# PREVIOUS FLIGHT ANOMALIES BACKUP

# POST STS-107 FIRST FLIGHT CONFIGURATION CHANGES

# MCR 19755 ORBITER BOOM SENSOR SYSTEM (OBSS)

# MCR 19271 WCCS CHECK VALVE DELETION

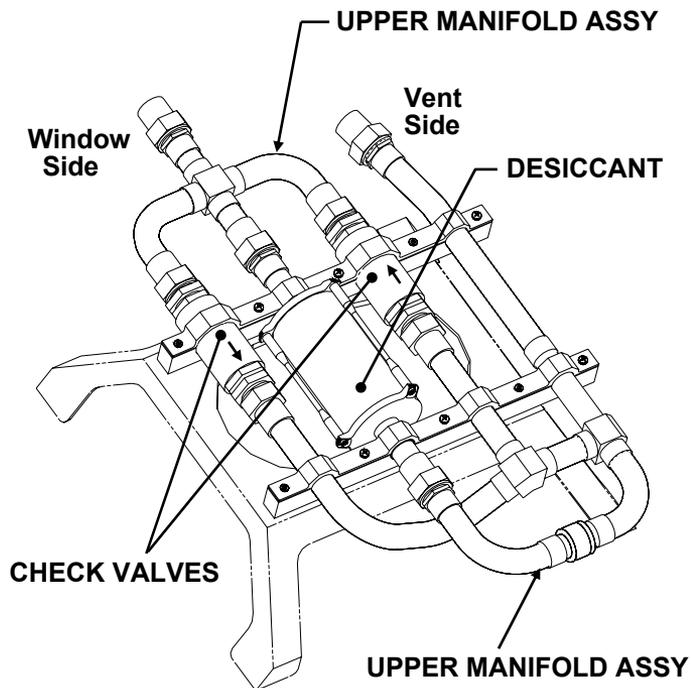
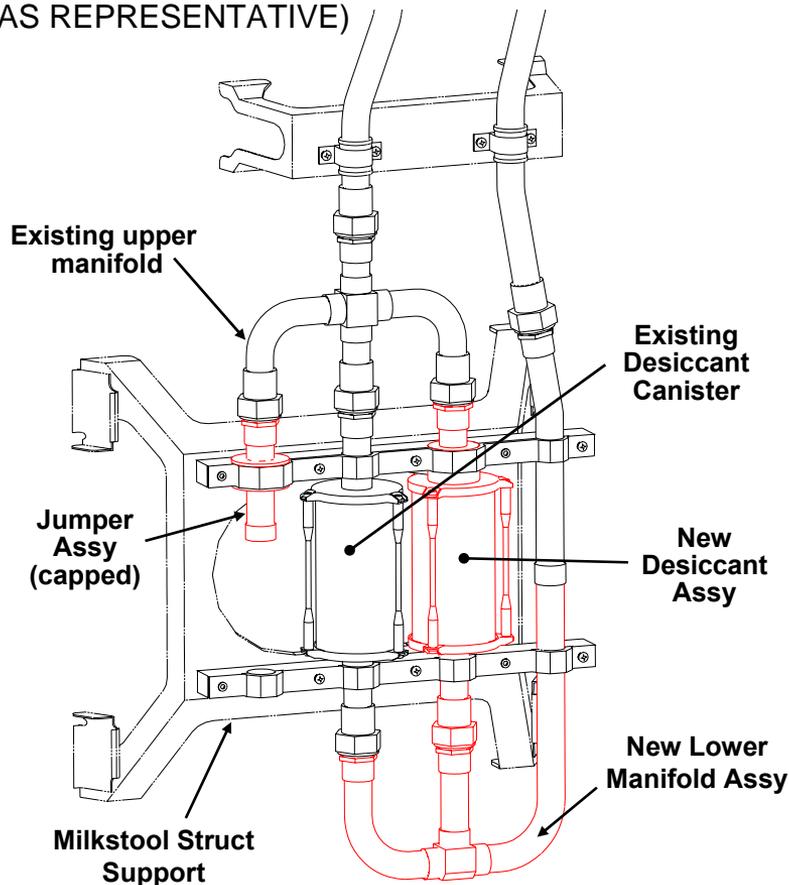
ORIGINAL CONFIGURATION

MODIFIED CONFIGURATION

# MCR 23043 MPS DELTA-P TRANSDUCER REMOVAL

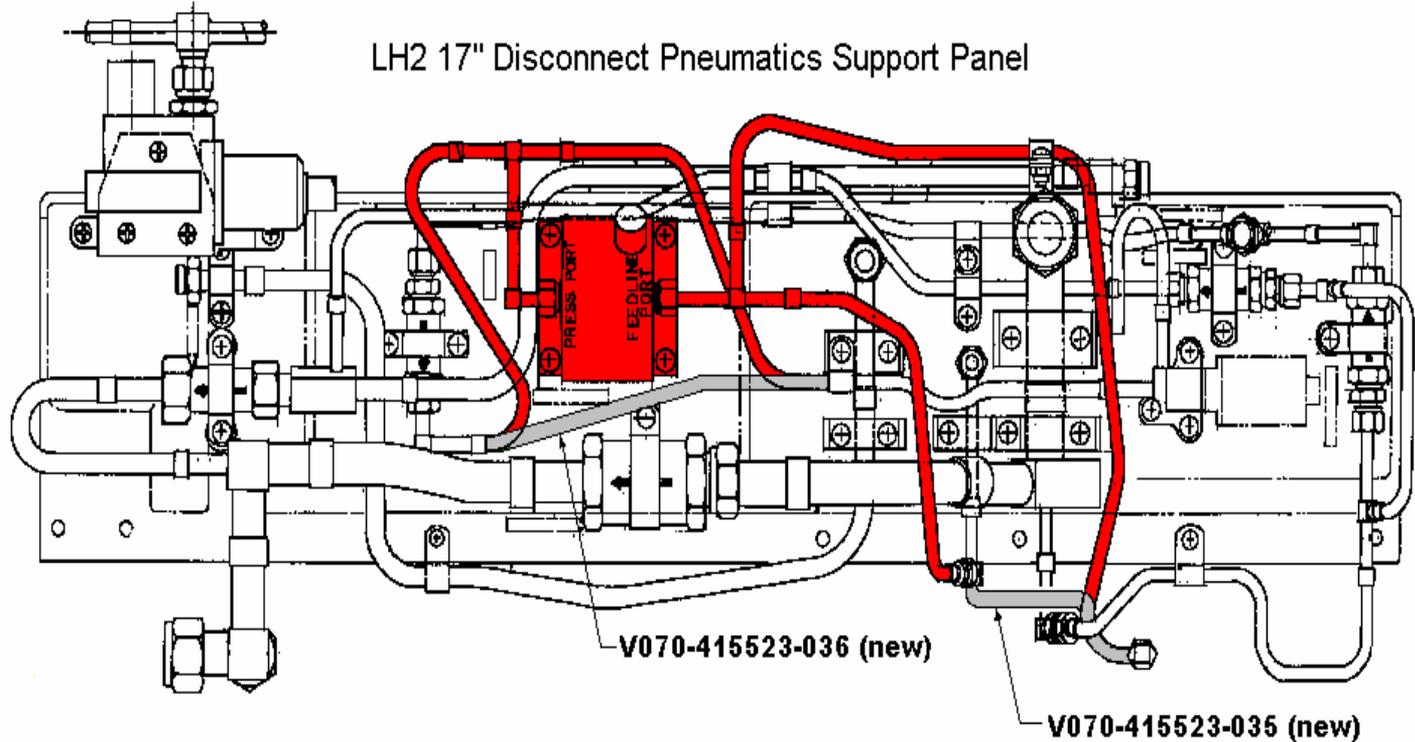
- The delta-P transducers have crit 1 CIL's for structural failure, but are no longer used
  - Used early in the program to constantly monitor propellant levels during tanking (not used during flight)
    - Provided a means of determining the propellant level in the ET LH2 and LO2 tanks between the point sensors in the bottom and top of the tanks
  - ET loading is now accomplished by timers and other system parameters based on experience of over 200 tankings
- Mod removes the delta-P transducers and their associated components/wiring as a safety improvement / risk reduction action
  - Eliminates associated criticality tracking, weight penalties of the unused hardware, and frees up 2 pressure (OI) data channels
  - Brings OV-103 and, and in a future flow, OV-104 in line with OV-105 original build configuration

# MCR 19569 MPM PYRO HARNESS MOD

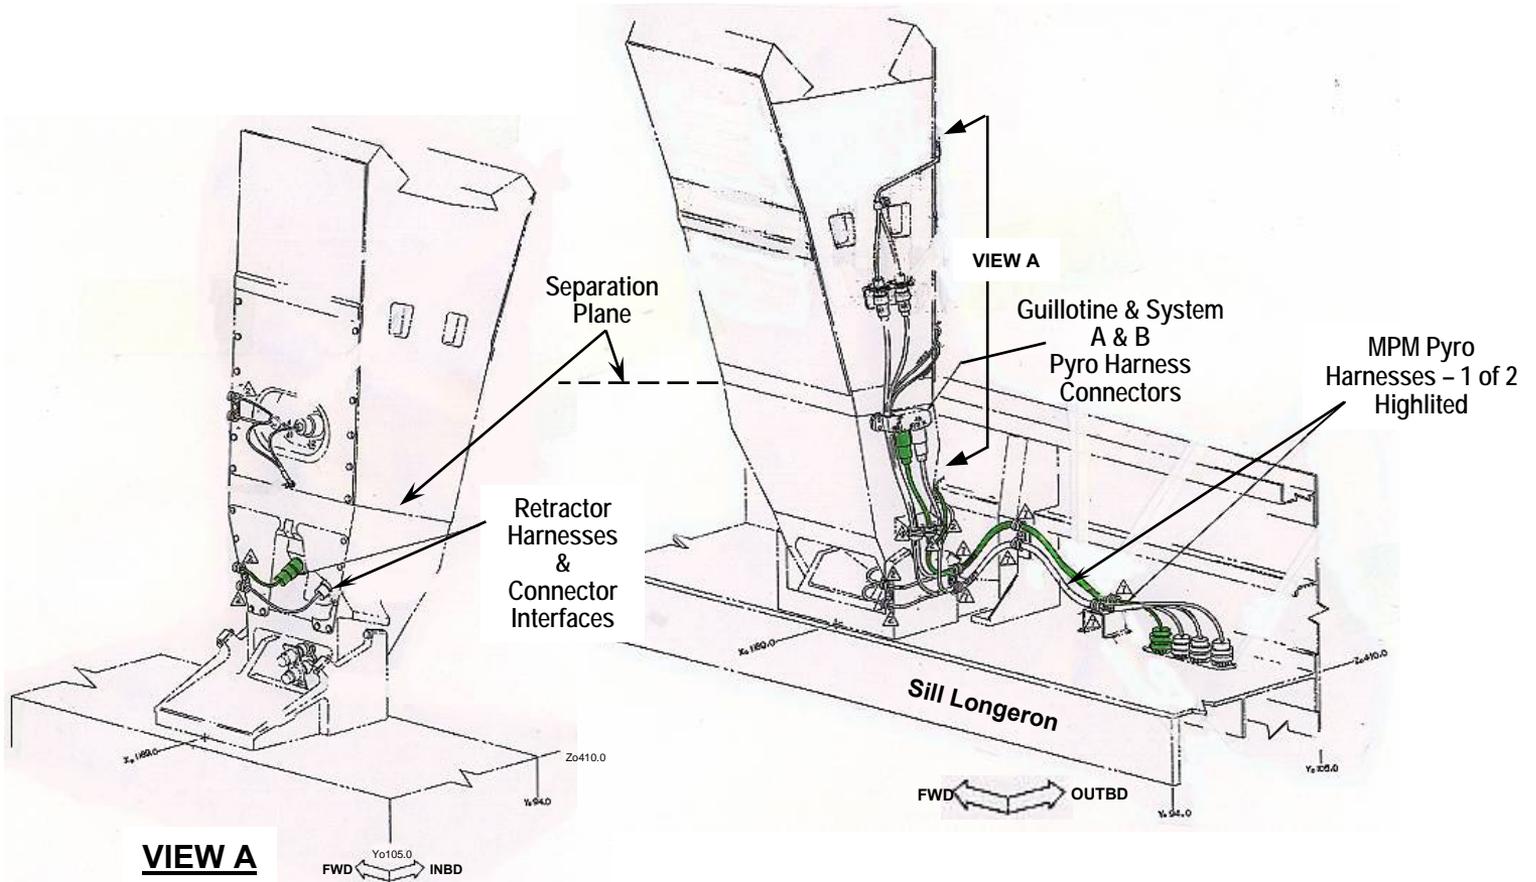
- MPM wire harnesses are multi-leg, carrying both pyro jettison circuits and MPM functional circuits
- Corrective action implemented because harness connector ID tags for jettison system retractor leg and guillotine leg had been previously found to be reversed
  - If the MPMs were required to be jettisoned, reversed installed harness would result in the Guillotine and the Retractor being fired simultaneously (out of normal sequence)
  - Analysis showed that, while this is not a desired situation, MPM separation will not be impeded by uncut wires
- Mod reworks existing MPM wire harnesses into two individual harnesses: one non-pyro and one pyro harness
  - Also changes the clocking of the guillotine pyro harness connectors to be different from the retractor connectors to preclude the possibility of harnesses connectors being improperly mated
